From: Williams, Jeffrey
Sent: Wednesday, May 22, 2024 2:12 PM
To: 'keswickyoung@verizon.net'
Subject: RE: 1723 Underwood Drive

1723 UNDERWOOD RD.

FLOOR PLAN

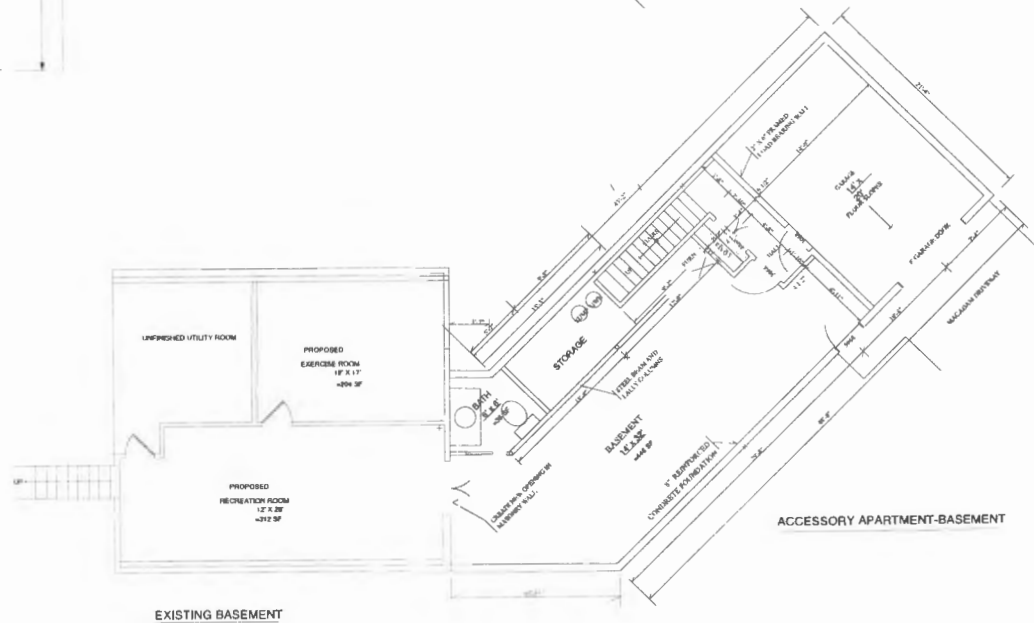
That is not what was permitted by our office. I'll need a floorplan of the whole existing house and the addition please.

The regulations state that any increase in living space requires a sewage disposal area. The issue on this lot is that the existing disposal area is partially encumbered by the house and some failing holes prevented us from finding alternate area back up to the regulatory required 10,000 sq ft. Because of the issues we encountered in the process, I allowed the addition to proceed without signing a revised perc cert plan, but I stated any future additions would likely require full completion of that requirement. Thanks

Hello. I'm confused by the site plan. Is this proposed work in the original house basement or in the basement of the new addition? The original permit and floor plans indicate an addition with an unfinished basement. The new floor plan here seems to show finishing the existing house and indicates a finished basement of recent addition, which was not part of the original permit we approved.

Thanks. Since it is a half bath on one side and no additional bathrooms on the other side and this is a revision to the same building permit, I signed off on the revision. Please note that any future building permits for any additional living space or change in house footprint will trigger the requirement to revise the sewage disposal area via additional perc tests and a revised perc certification plan. Thanks
Jeff
